Access Compliance Report

Public Rights-of-Way

Intersection ID: 15036	Main Street: MAGNOLIA_AV	Cross Street: MCDONALD_AV	Location: SE
ADA ID: CB0E7B69856D	Ramp Type: Directional1	Initial Pass/Fail: Fail	Overall Compliance: No
		Severity Score: 25

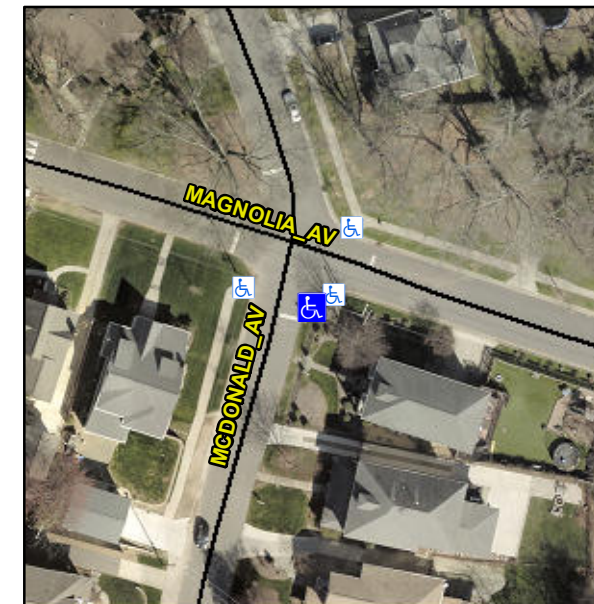
R304.5.3

Compliance	Description	Data	Compliance	Description	Data
N/A	Ramp Length (in)	84.0	N/A	Grade Break?	N/A
Yes	Ramp Width (in)	57.0	N/A	Grade Break Slope (%)	0.0
Yes	Ramp Slope (%)	2.1	N/A	Grade Break XSlope (%)	0.0
No	Ramp XSlope (%)	7.4			
N/A	Flare Type LT	N/A	N/A	Flare Type RT	N/A
N/A	Flare Slope LT (%)	N/A	N/A	Flare Slope RT (%)	0.0
N/A	Flare Traversable LT?	N/A	N/A	Flare Traversable RT?	N/A
N/A	Landing Length (in)	0.0	N/A	DWS Provided?	N/A
N/A	Landing Width (in)	0.0	N/A	DWS Contrast?	N/A
N/A	Landing Slope (%)	0.0	N/A	DWS Length (in)	N/A
N/A	Landing X Slope (%)	0.0	N/A	DWS Full Width?	N/A
N/A	Landing Curb? (Y/N)	N/A	N/A	DWS Offset LT (in)	N/A
N/A	Shared Landing?	N/A	N/A	DWS Offset RT (in)	N/A
N/A	Gutter Ponding?	0.0	N/A	Gutter Slope (%)	N/A
N/A	Gutter Lip Ht (in)	0.0	N/A	Gutter X Slope (%)	N/A
N/A	Painted X Walk1?	No		Road Slope (%)	6.3
	X Walk 1 Direction	To W		Road X Slope (%)	5.4
	X Walk 1 Width (in)	N/A		Clear Space?	N/A

Remove & Replace Entire Ramp.
